Sydney Modern Project Further traffic clarifications

Arup has reviewed the request for further information from the Department of Planning & Environment and the submissions made by Don Smith/Wharf Terraces Strata Committee and Transport for NSW. Further traffic clarifications in response are provided below.

Drawing Title
Turning Paths
Bus bay

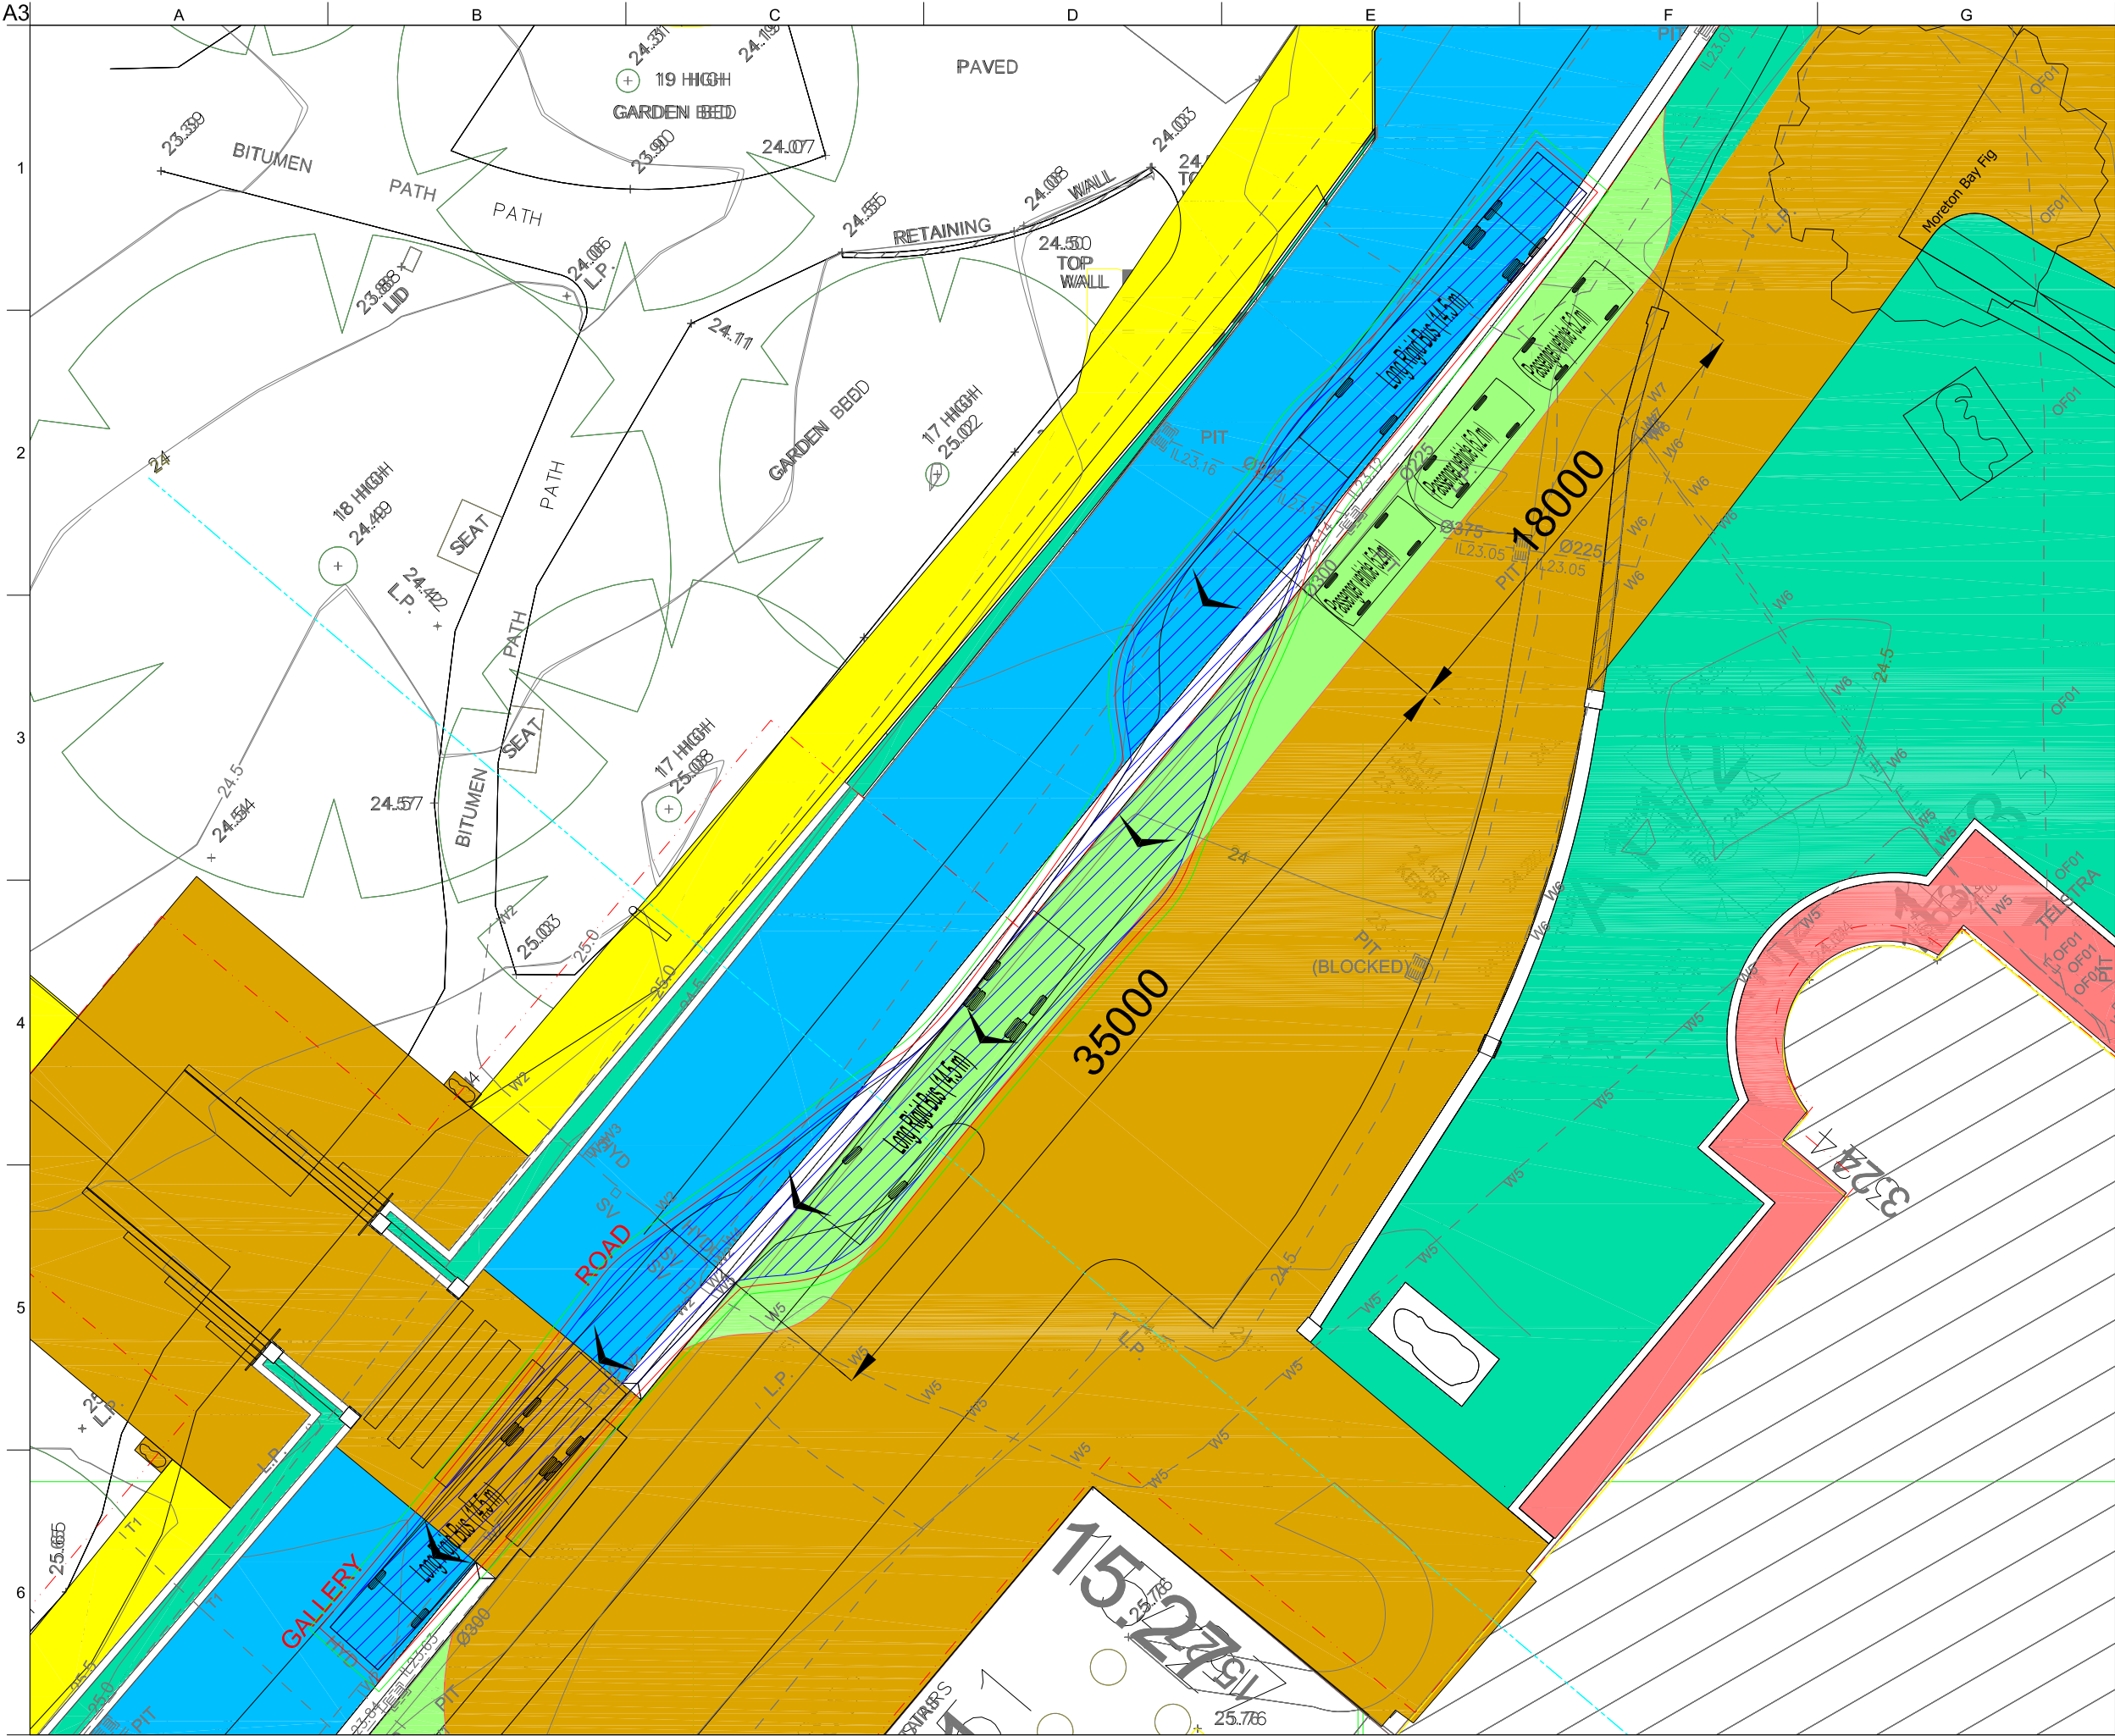
provided post approval. It is suggested that the detailed CPTMP be undertaken in consultation with local residents and/ or key stakeholders such as the Wharf Terraces.
Demonstrate 14.5m buses will be able to utilise the proposed bus stop (see TfNSW RTS submission).	The design of the indented bus bay to accommodate a 14.5m bus will be in accordance with the NSW Government, State Transit Bus Infrastructure Guide. See attached Arup drawing SKT-001 for the 14.5m swept path.
The EIS referred to 32 staff bicycle spaces. However, the current plans denote only 12 staff bicycle spaces within the loading dock.	There are 10 staff bicycle parking spaces in the existing loading dock which will be retained. Currently an additional 12 bicycle parking spaces are shown in the new loading dock to meet the DCP requirement from the new gallery floor space. (12,000m ² @ 1 /1,000m ² = 12 bicycle spaces). The traffic impact statement accompanying the EIS referenced a requirement for 32 bicycle spaces, i.e. 10 additional spaces than now currently proposed. Note this was predicated on a previous proposal that included upgrades to the existing Gallery building which were not included in the project scope at lodgement, and are therefore not required.
